Remarks

Upon entry of the foregoing Amendment claims 1-47 are pending in the application. Claims 1, 3, 4, 6, 13 and 14 are sought to be amended. Claims 15 to 47 are sought to be added to provide the Applicants with alternative claims that provide the scope of protection to which the Applicants are entitled. These changes are believed to introduce no new matter, and their entry is respectfully requested.

Proposed drawing corrections are enclosed and highlighted in red. The corrections replace or add several reference numerals; so that, the drawings correspond to the related text. The corrections also correct minor informalities discovered by the Applicants. No new matter has been added.

Figure 4

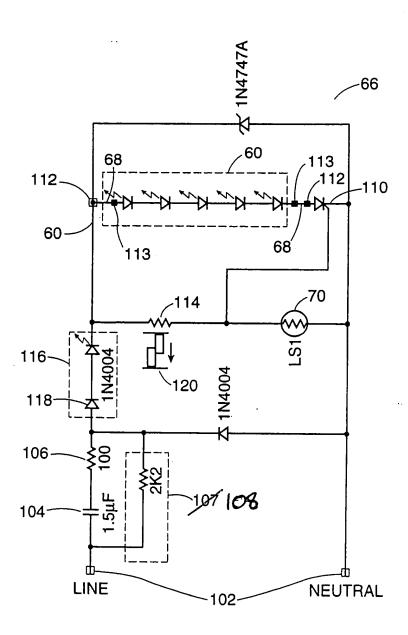
Power circuit 66 comprises the components outside circuit 60 in Fig. 4. In power circuit 66, capacitor 104 and resistor 106 cause the -- <u>line voltage 102</u> [voltage] -- in power circuit 66 to drop to a level which can be handled by light circuit 60. Alternatively, capacitor 104 and resistor 106 may be replaced by single resistor 108. Single resistor 108 must be of sufficient resistance to drop the voltage to the required operating levels of light circuit 60. It can be appreciated that a variety of known circuit arrangements are available which may be utilized to effectively drop the 120 volt AC signal to a signal which can be used by light circuit 60.

FIG.
Figure 9a

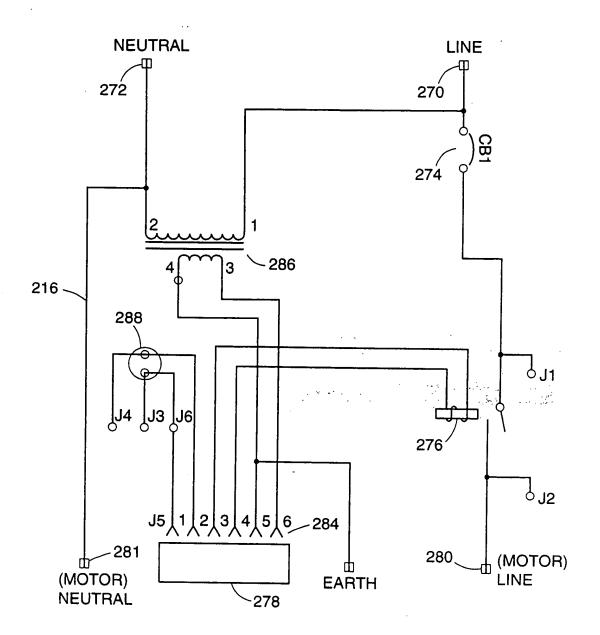
Transformer 286 provides a 24-volt signal -- [appears] -- between terminals 286(3) and 286(4) when a 120-volt AC signal is present between terminals 270 and 272 -- [(Fig. 9a)] --. Relay 276 is energized on the positive portion of an AC signal between terminals 286(3) and 286(4), via auxiliary circuit 278. Controller 216 interfaces to auxiliary circuit 278 through connector 290.

Figure 12

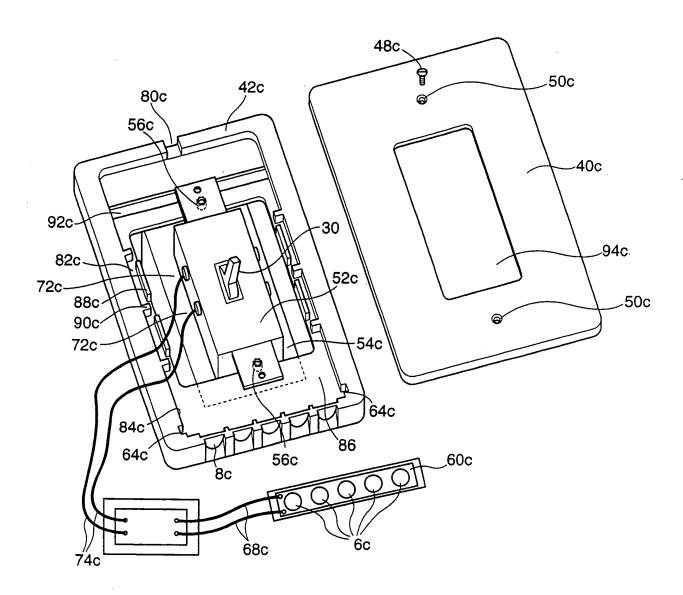
Referring to Fig. 12, the layout of components of frame assembly 2c is similar to the layout for components for frame assembly 2b (Figs. 3a and 3b). Light switch 52c is mounted to electrical box 54c via screws 48c inserted through -- apertures 50c and -- hollow spacers 56c on frame 42c. Hollow spacers 56c allow -- [connections 58c of] -- light switch 52c to be flush with the front surface of cover 40c.
